SERIAL NO. 09/649,559

Reply to Office Actions of 10 May 2004 & 18 Nov. 2004

APPENDIX

Amendments to the Drawings

FIG. 2

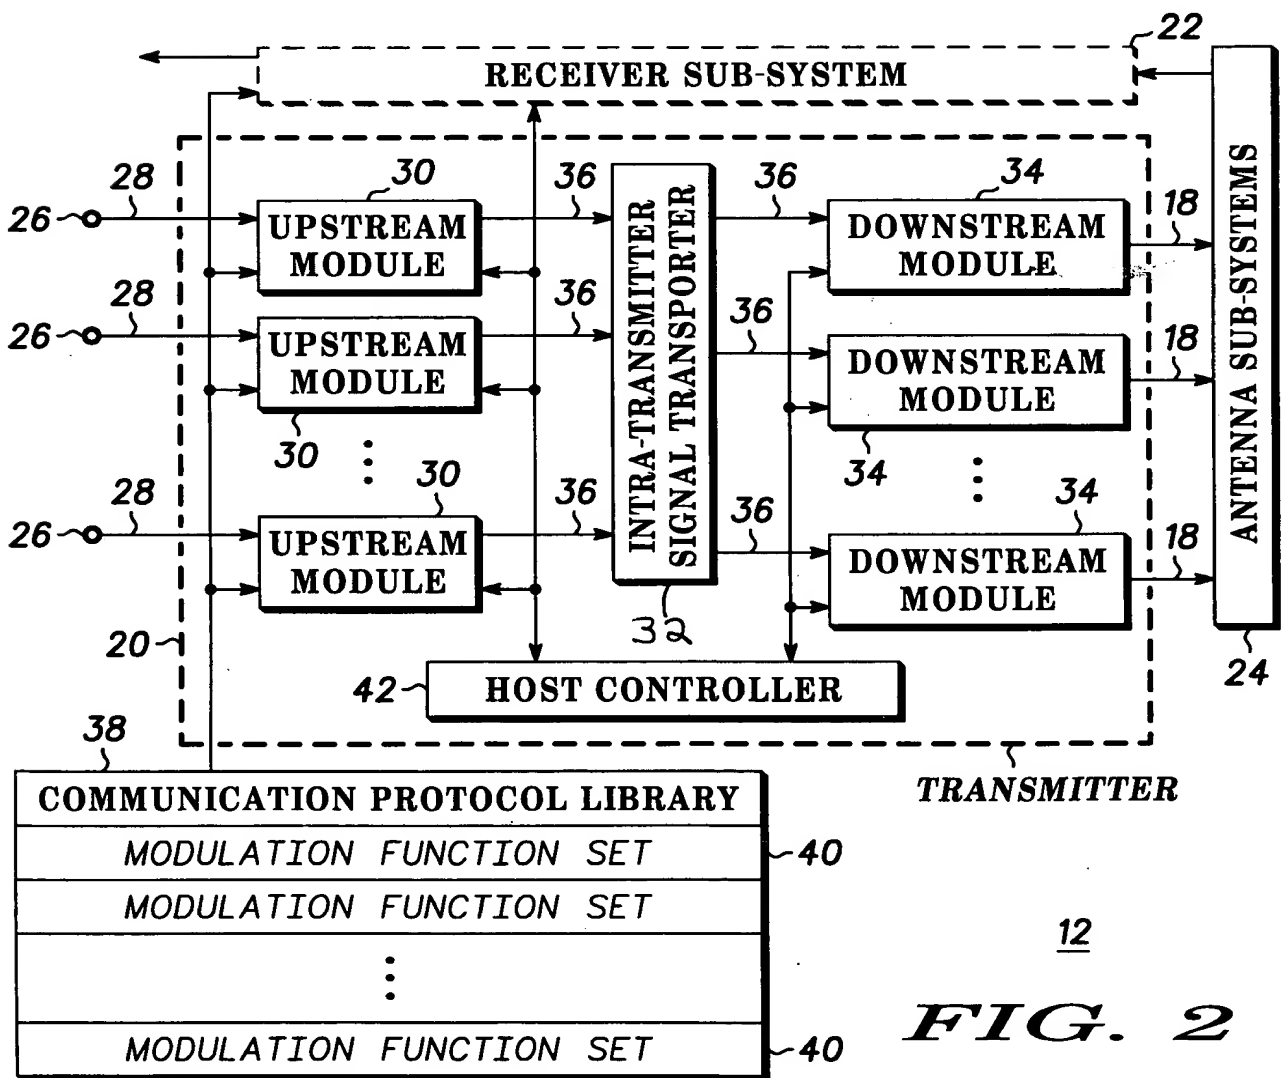
Section 1 on page 2 of the 10 May 2004 Office Action objected to Fig. 2 due to the omission of reference number "32". The amendment to the drawings herein corrects this omission. Accordingly, applicants believe this objection has been overcome.

The Appendix hereto includes changes to Fig. 2 on sheet 1 of 3 of the drawings. In particular, the reference number 32 has been added in reference to the block labeled "INTRA-TRANSMITTER SIGNAL TRANSPORTER." Appendix A includes a marked-up sheet 1 of 3 which highlights the change to Fig. 2, along with a replacement sheet 1 of 3 and three copies of the same.
